To:	Tim Carter Carter Group Level 2, ASB House, The Crossing 166 Cashel Street, Christchurch 8011 Christchurch	From:	Laura Drummond Level 3, 2 Hazeldean Road Addington, Christchurch 8024 NEW ZEALAND Mail to: PO Box 13052, Christchurch 8140
Project/File:	Ōhoka FTAA	Date:	10 September 2026

Reference: Ōhoka FTAA aquatic ecology – response to Environment Canterbury comments

DESCRIPTION: WATERCOURSE AND
WETLAND CHANGES
OVERVIEW PLAN

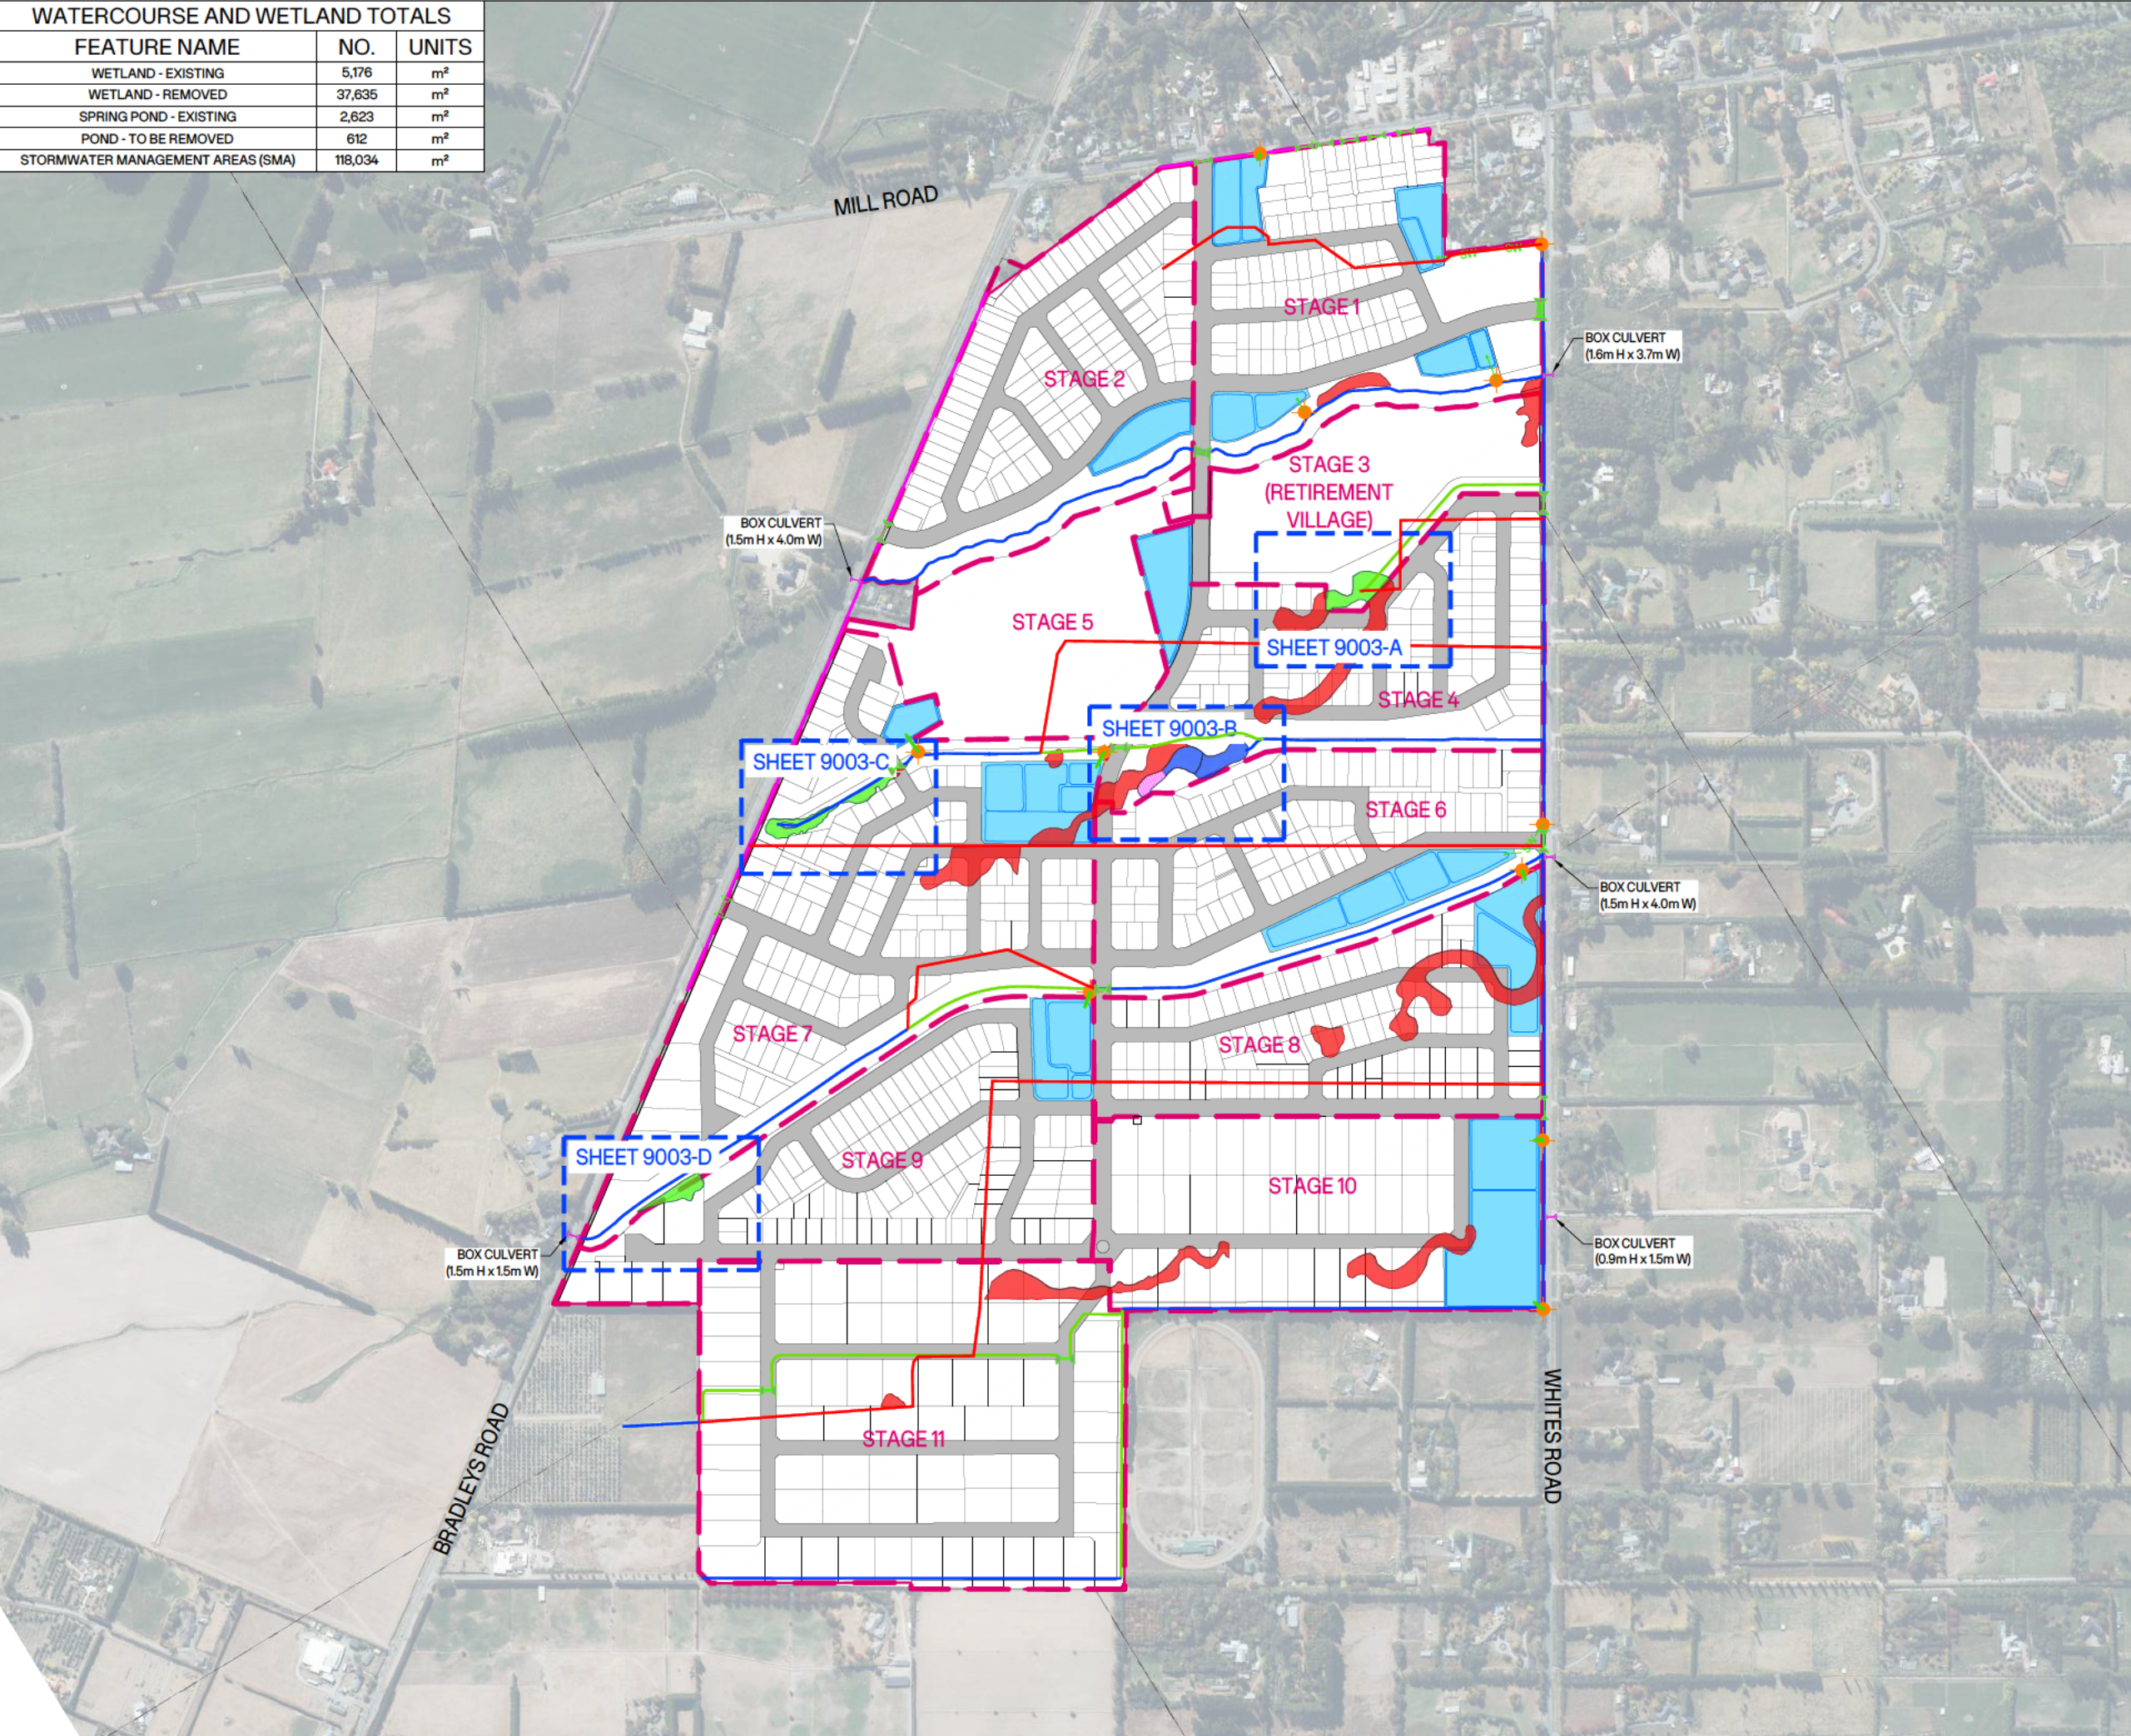
flows. This includes the first 25 mm of rainfall to be attenuated within basins and wetlands, with discharge volume controlled at the outlets. It is noted that the reviewer had not seen the updated site map which showed the proposed stormwater discharge locations. A marked-up drawing showing the stormwater discharge locations was provided during the meeting. Attached to the end of this document is a similar plan, which has been updated with revised Stormwater Management Areas (SMAs) as well as the SMA outfall/discharge locations (see the orange dots as per the legend). The following text is provided to clarify expected effects to the identified discharge locations.

The reviewer raised concerns in the meeting on 12 August 2026 that the mixing assessment was undertaken on one stream only (Ōhoka Stream Tributary), when discharge was to occur in multiple locations. Treated stormwater discharge is proposed within the three main streams on-site, as well as to roadside drains along Mill Road and Whites Road. The Water Quality Assessment⁴ undertaken used a modelling-based assessment of stormwater discharge to the Ōhoka Stream Tributary, which has four discharge locations, to provide an assessment against discharge conditions within the most sensitive and high-value stream within the site. The approach undertaken therefore provides a conservative assessment example of highest quality receiving environment on the site and is considered appropriate for comparison with treated stormwater discharges to the Northern Spring Channel, South Ōhoka Branch and perennial sections of Whites Road Drain. Mill Road treated stormwater discharge is to an artificial roadside drain that is typically dry, primarily providing stormwater flow conveyance. Therefore, adverse effects to aquatic ecology values are expected to be very low as a result of this discharge.
